## PLANNING COMMISSION MEETING AGENDA

Department of Community and Economic Development  
Meeting Date: September 4, 2019

##### 3.1. (Project CUP-19-008)

# PLANNING COMMISSION STAFF REPORT

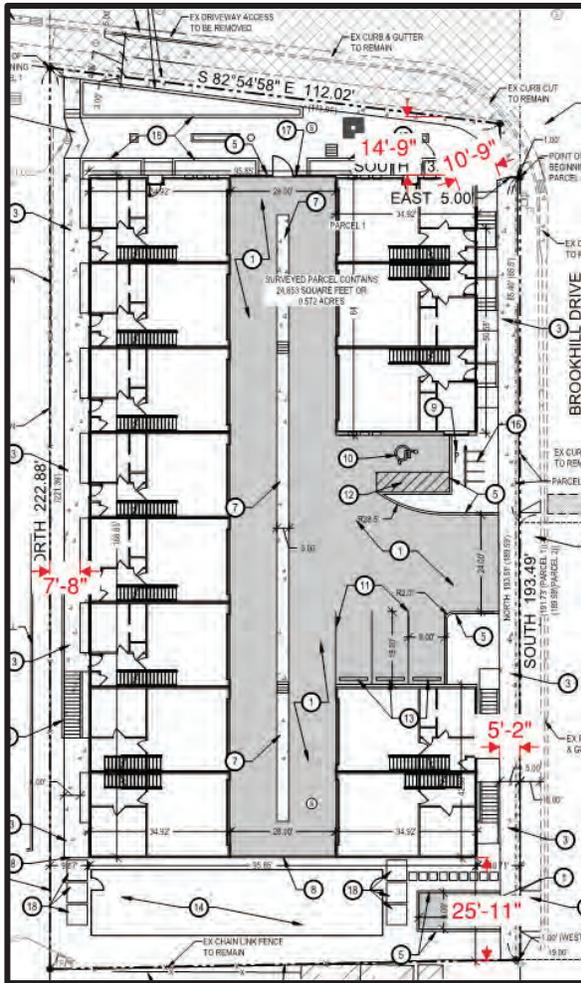
The proposed building is three stories and 38 feet from the average existing grade to the highest point of the roof structure. The maximum height permitted in the MU zone is two stories and 35 feet. The Planning Commission may increase the maximum height to no more than three stories and 45 feet if the increased height will not adversely affect the public health, safety or welfare:

The finished floor elevation at the southwest corner of the building is 9.3 feet below existing grade. Because the floor is more than eight feet below existing grade at the corner, the lowest story of the building does not qualify as a story for the purposes of measuring structure height:

**Analysis:** A conditional use permit is required to increase the maximum height from 35 feet to 38 feet. While 38 feet is the overall height of the building as measured from the average existing grade, the slope of the lot effectively decreases the observed building height from 40 feet along Fort Union Blvd. to 30 feet where adjacent to residential to the south. Increasing the building height along Fort Union Blvd. is consistent with the goals of the Fort Union Corridor Plan. Staff recommends approval of the height increase as depicted in the plan submittal.

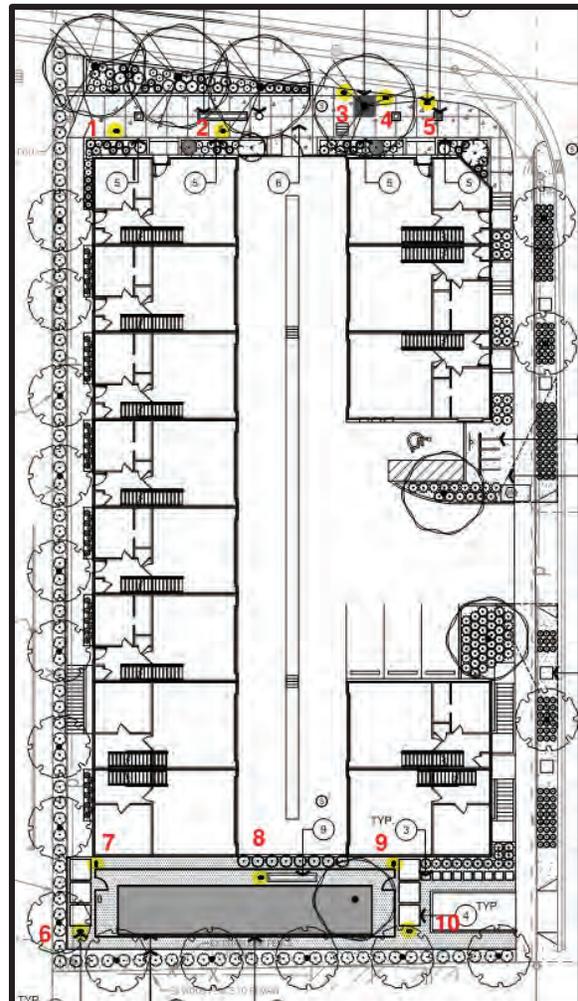
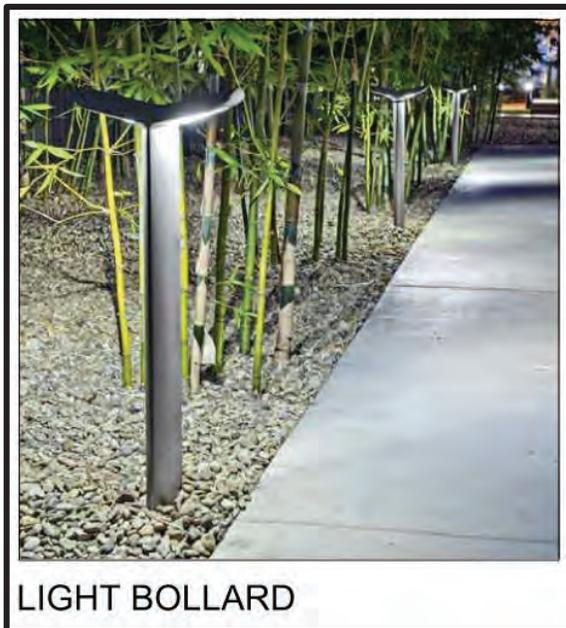
The applicant has submitted a landscape plan that shows 10 bollard lights (5 in the front along Fort Union Blvd. and 5 in the landscaped area in the back). No plans have been submitted for building-mounted or canopy lighting. There is an existing street light at the corner of the property on a power pole. Pedestrian walkways in the MU zone must have a lighting plan.

**Analysis:** The applicant must submit a lighting plan that demonstrates compliance with section 19.36.120 of the zoning ordinance and the lighting standards of the Architectural Design Guidelines.

1. Receive a Certificate of Design Compliance from the ARC;
2. Submit a lighting plan that demonstrates compliance with section 19.36.120 of the zoning ordinance;
3. Submit a plan with details for all equipment and dumpster locations and screening if applicable and a plan for residential waste and recycling pickup;
4. Submit a plan with exact setbacks showing the minimum distance from any portion of the building intended for human inhabitants to the property line;
5. Submit a lighting plan with details about building mounted lighting that complies with section 19.36.120 of the zoning ordinance;
6. Verify the appropriateness of the proposed street trees with Rocky Mountain Power;
7. Work with staff to provide full frontage improvements in accordance with the Fort Union Corridor Plan and city right-of-way standards.

**Ft. Union Corridor Master Plan Cross Section**

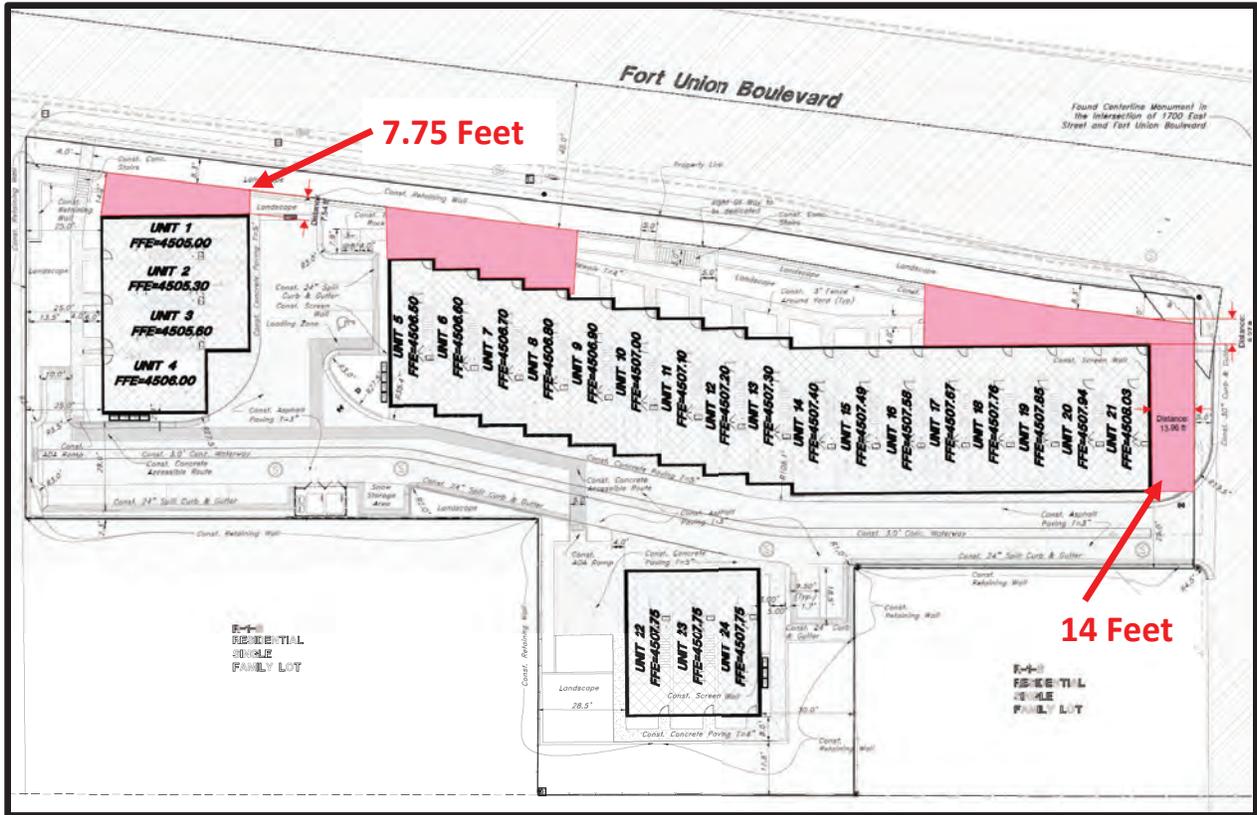
**Analysis:** This requirement is discussed first as it effects the applicant’s proposed setbacks.

The west side and south rear setbacks all meet the required setbacks for building adjacent to single-family residential properties. The applicant is requesting an exception to the north front and east side yard, 7.75 and 15 feet, respectively. However, it should be noted that the average setback along the front yard is 18 feet. Also, the City is requiring the dedication of 8 feet of the front yard for future improvements to accomplish the goals of the Fort Union Corridor Master Plan for redesigning the street into a pedestrian-friendly, mixed use, downtown environment.
